ADDENDUM NO. 3

**RE: NCDAC NC Correctional Institution for Women
Air Conditioning Installation
SCO ID#: 22-24913-02A
NCDAC Central Engineering Job Order # 4290**

DATE: September 12, 2023

3 DORMITORY ENLARGED MECHANICAL ROOM C-22
M102 Scale: 1/4" = 1'-0"

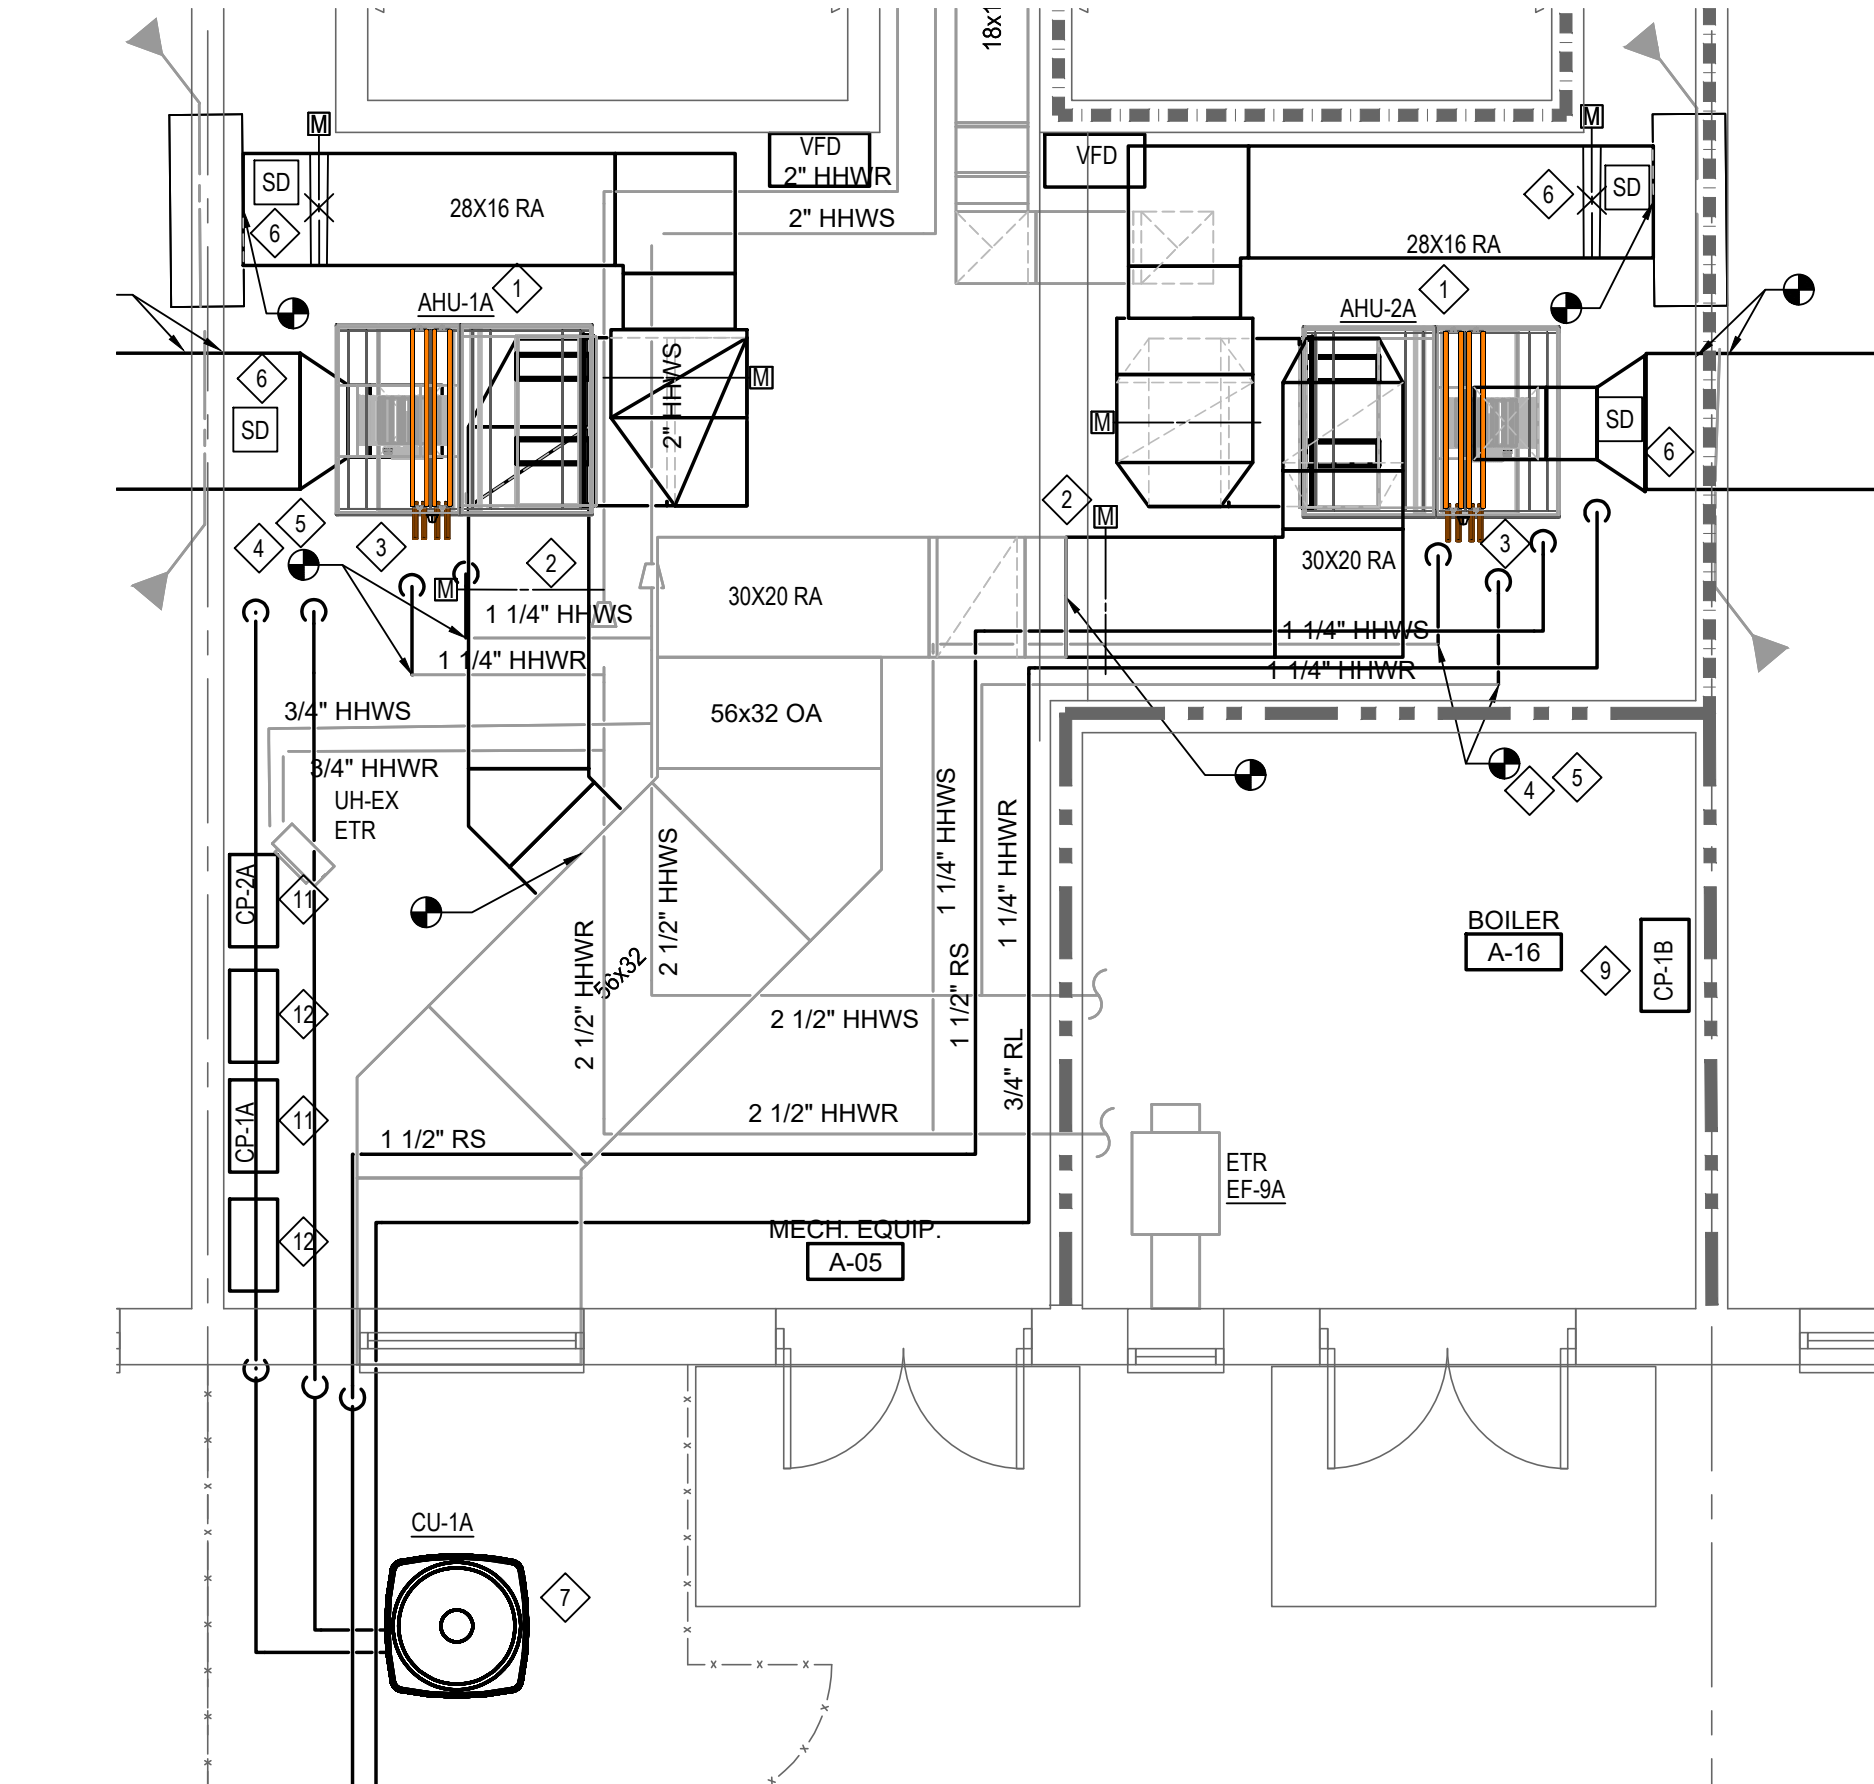
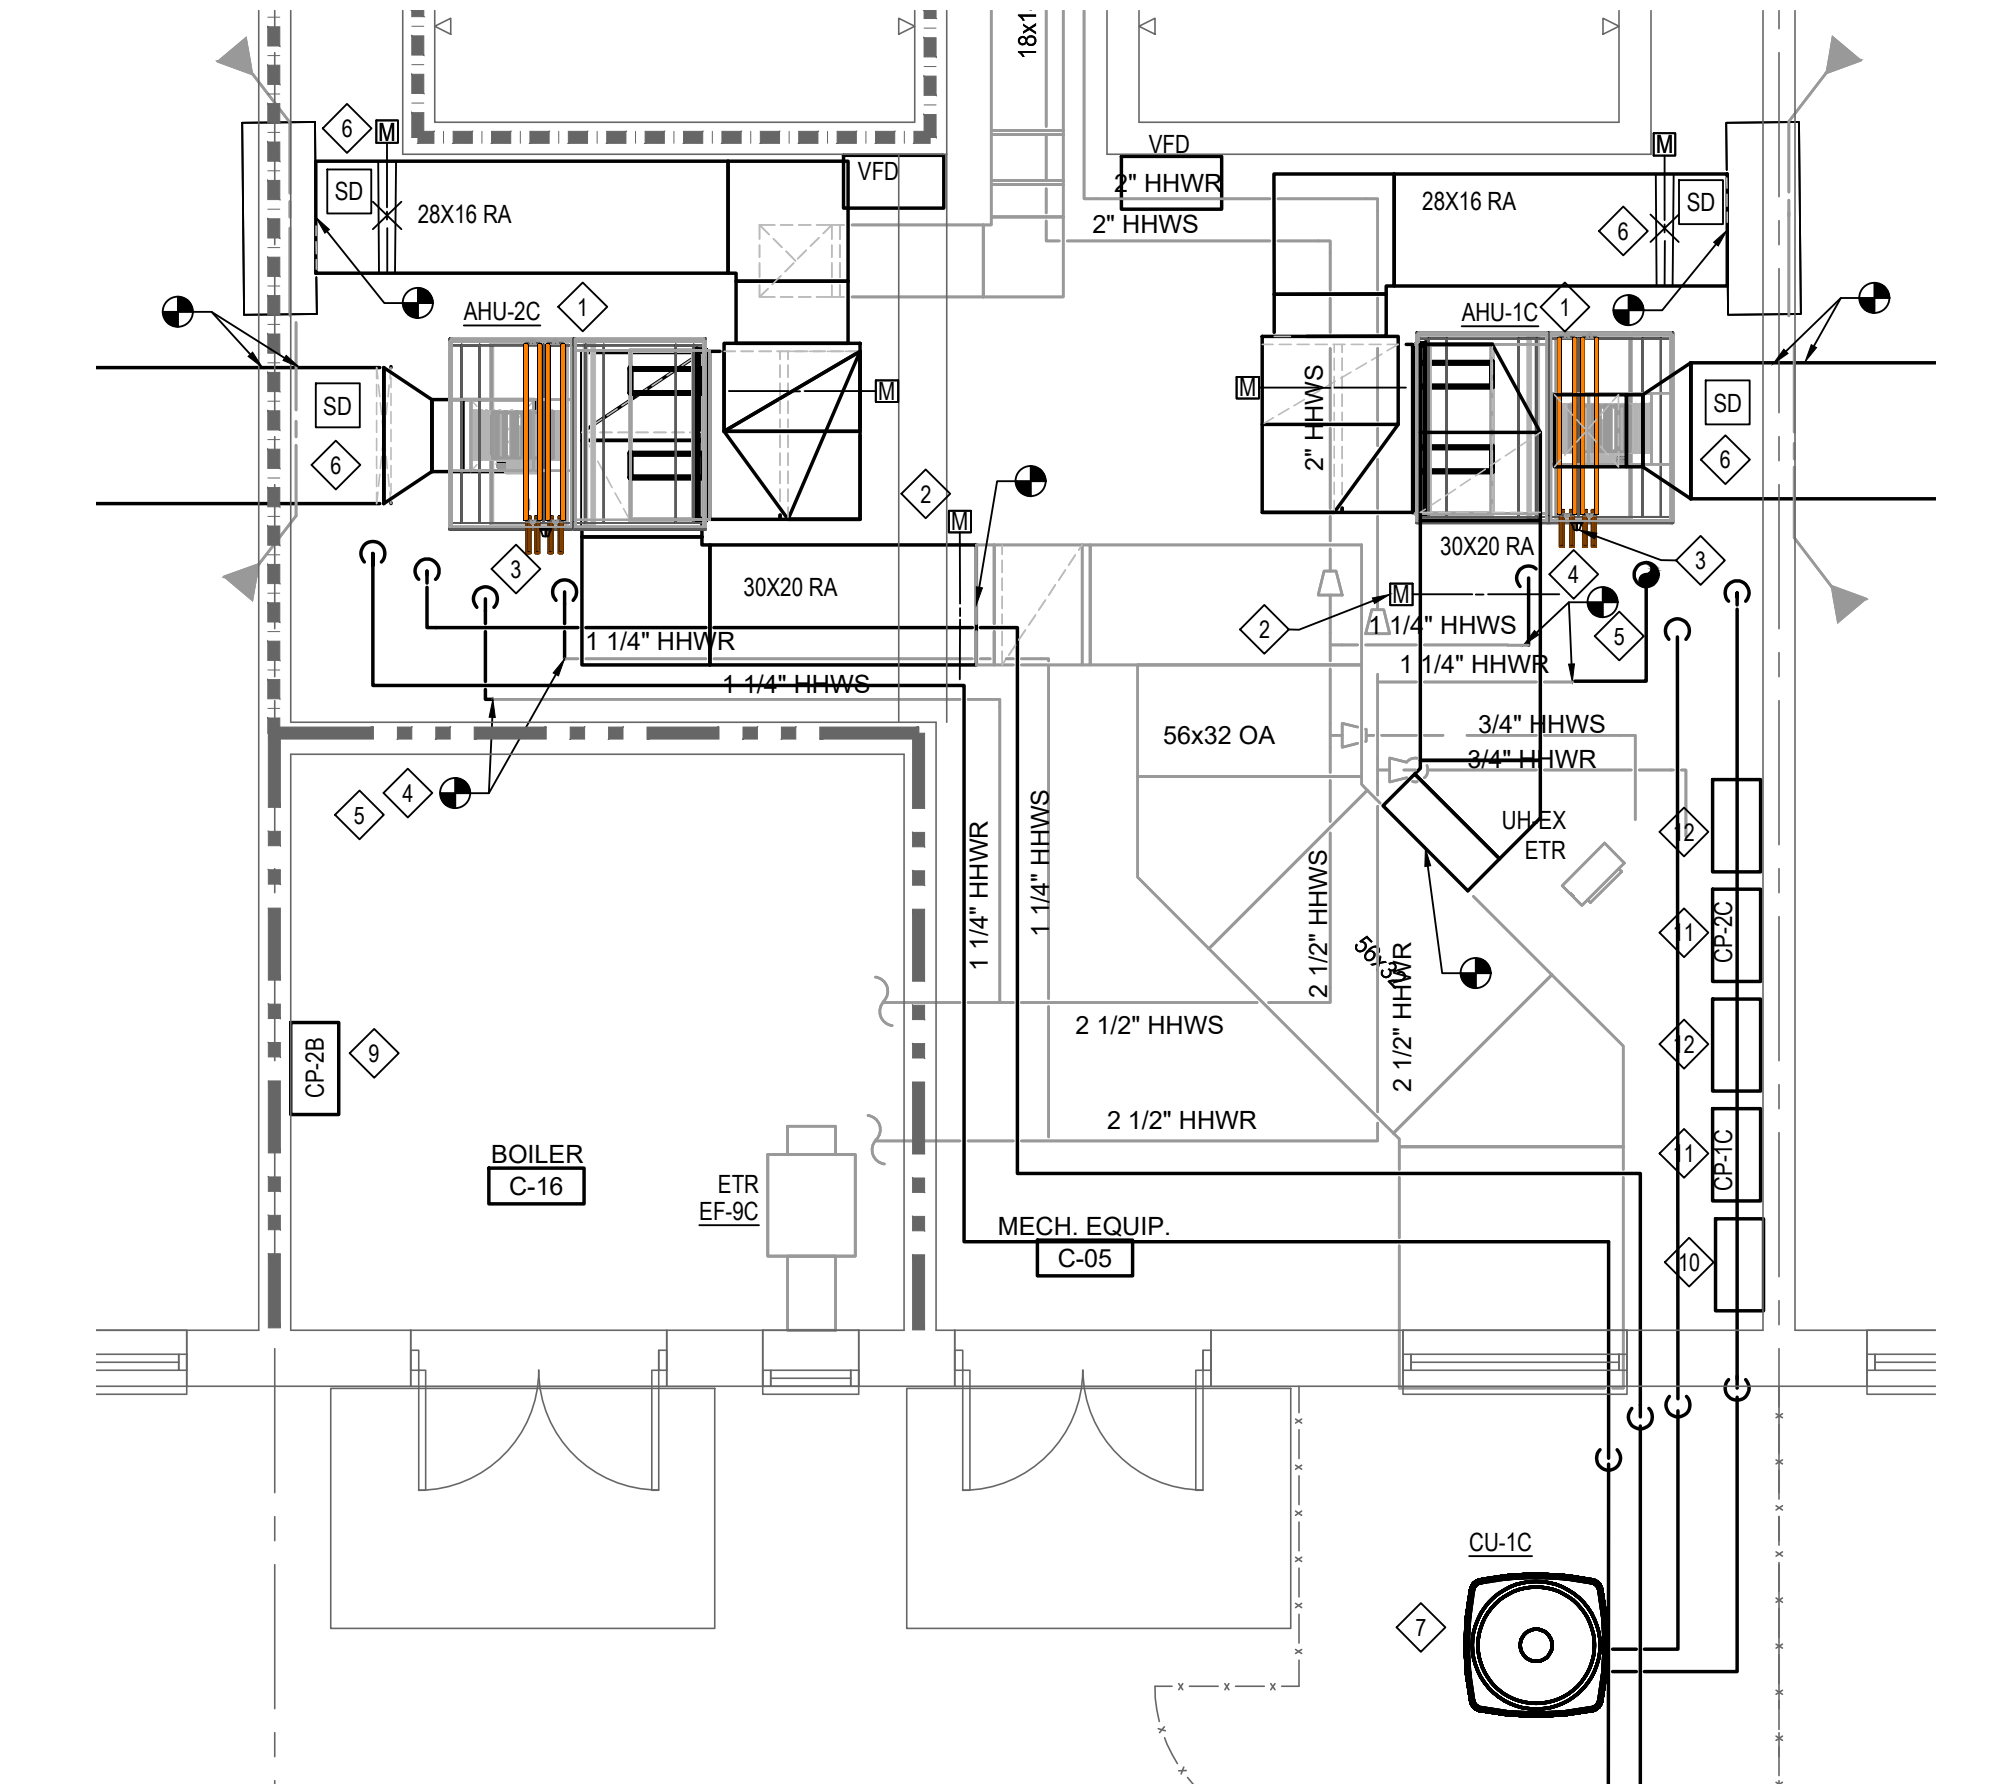
6. Sheet M220: Revised keyed note 1. See revision on attached sheet.
7. Sheet M401: Revised keyed note 6. See revisions on attached sheet.
8. Sheet M501: Revised ductwork detail. Exposed ductwork in dormitories shall be double wall insulated ductwork. See revision on attached sheet.
